| Title - Sujet Sand Shed Recladding | |
| Solicitation No. - N° de l'invitation EZ899-181525/A | Amendment No. - N° modif. 002 |

This Amendment #002 is raised to issue Addendum #01.

The following changes in the tender documents are effective immediately. This addendum will form part of the contract documents

Sheet / Feuille
R-2.1

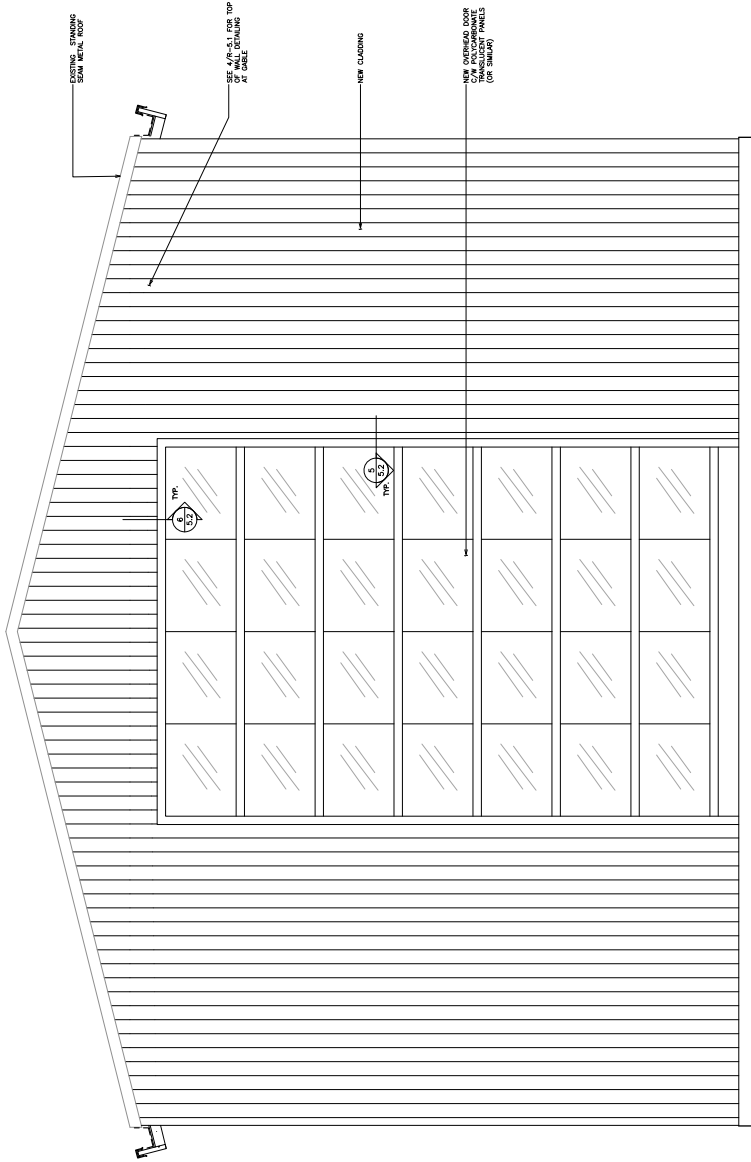
- 4.6** *“Drawing R-2.1, shows a drain but there is no detail on the works? Depth? Existing drain? Asphalt or concrete surface cover?”*
- 4.6.1** There is an existing drain. Reference Existing Floor Plan on the attached Drawing R-2.1 dated November 9, 2017 – ISSUED FOR ADDENDUM #1.

- 4.7** *“Drawing R-2.1, shows steel bollards. Any information on depth of bury? Type of bury? Surface treatment?”*
- 4.7.1** Reference Existing Floor Plan on the attached Drawing R-2.1 dated November 9, 2017 – ISSUED FOR ADDENDUM #1.

| Project No. / No. du projet | Sheet / Feuille | Revision no. La Révision no. |

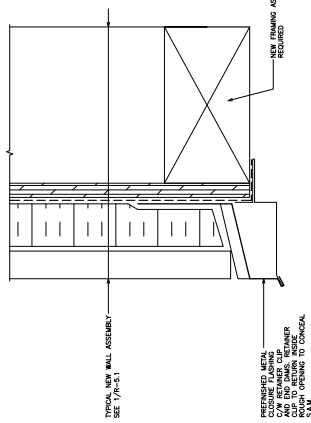
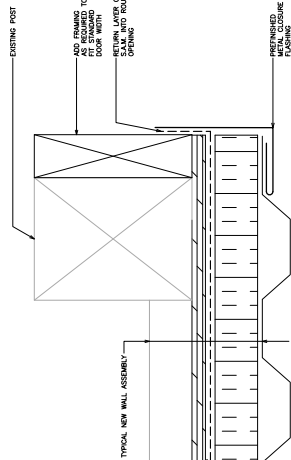
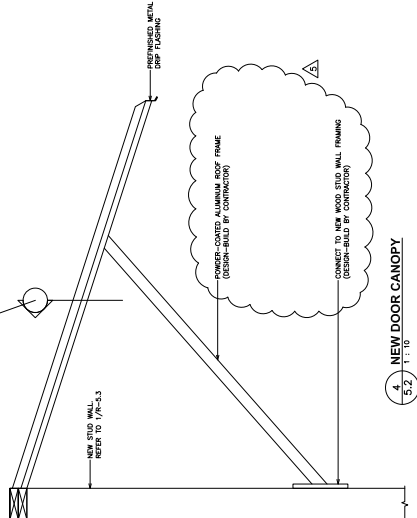
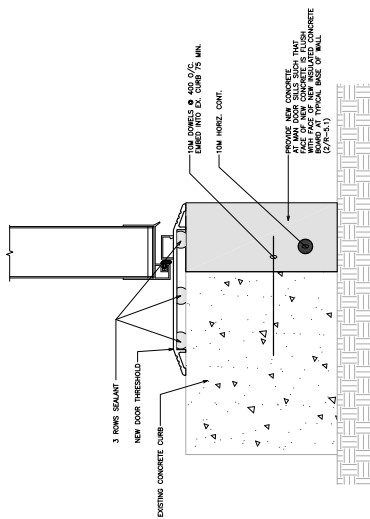
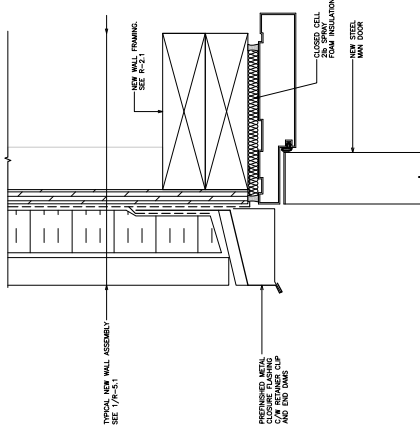
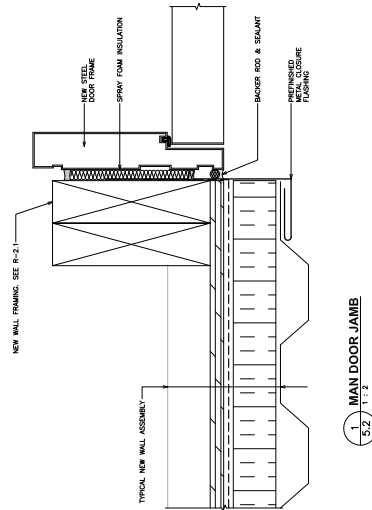
.10 Glazing: safety glass, fire rated to match door.

.2 Door size to be 36" x 80", complete with 22" x 30" tempered lite 43" above sill height. Right hand reverse.
